VM6052 / VM6054

CA.DT.B17-8e - November 2017

VM6052/VM6054 Hardware Release Notes

Item #RC-1 Centering pin prevent from 64bits PMC mounting on slot 1

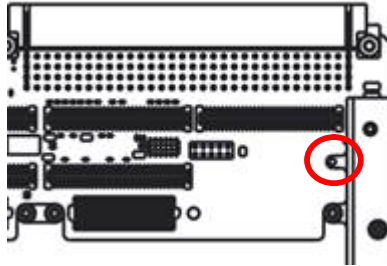
Description :	Centering pin (stud) highlighted by red circle in picture below prevent from 64-bit PMC mounting on slot 1. Extra connector for this kind of PMC bumps into this pin.
---------------	---

Impact:	Mounting of 64-bit PMC boards on slot 1 may be not possible. No problem for 32-bit PMC boards.
Workaround:	Fixed by mechanical E.C. Level D1 on VM6052/VM6054 PCB-C or higher.

Appendix C - PMC Excursion

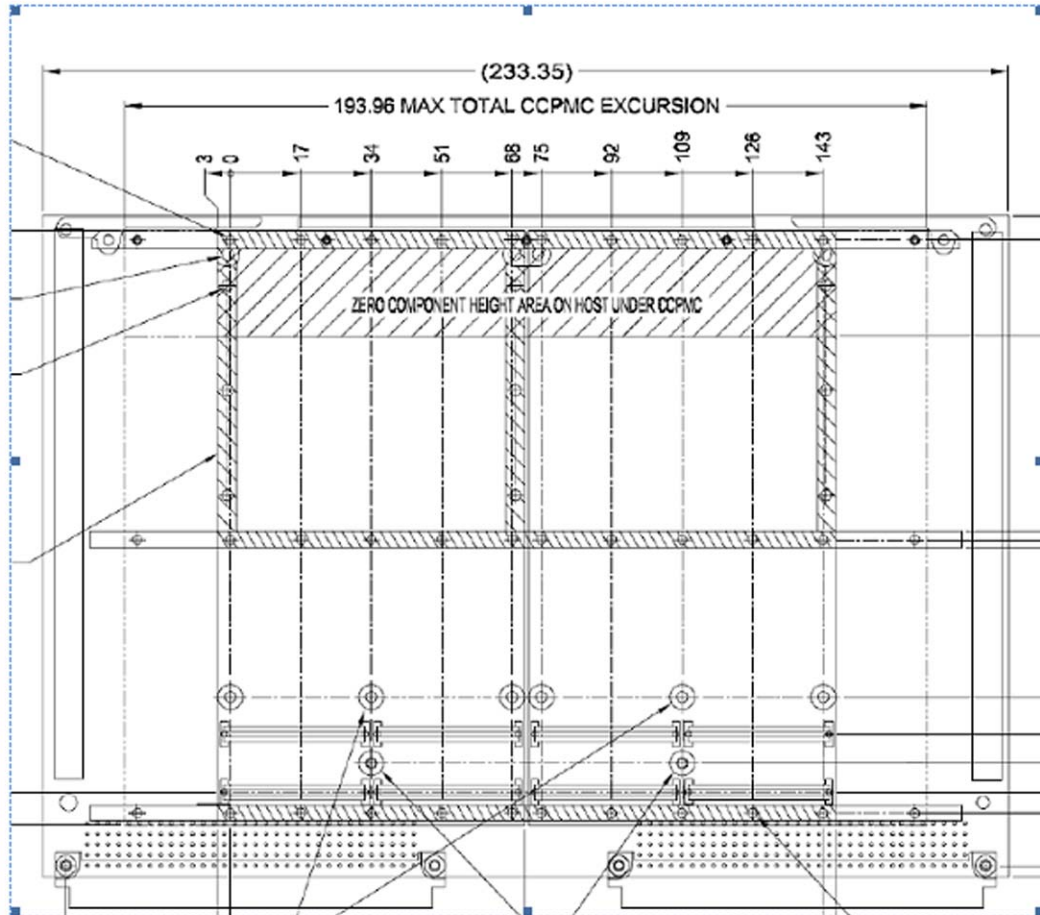
▶ **PMC excursion VITA 20 requirement not satisfied with RC class Ruggedizer - CRP 3982**

PMC location does not satisfy the PMC excursion requirement in VITA 20 standard (see appendix C). The distance from PMC edge to VM6052/VM6054 edge size must be higher than 19.7 mm as specified by the VME standard.

- ▶ 13.75 mm instead of the required standard of 19.7 mm at minimum

Ejector has been reduced to do not disturb with PMC.
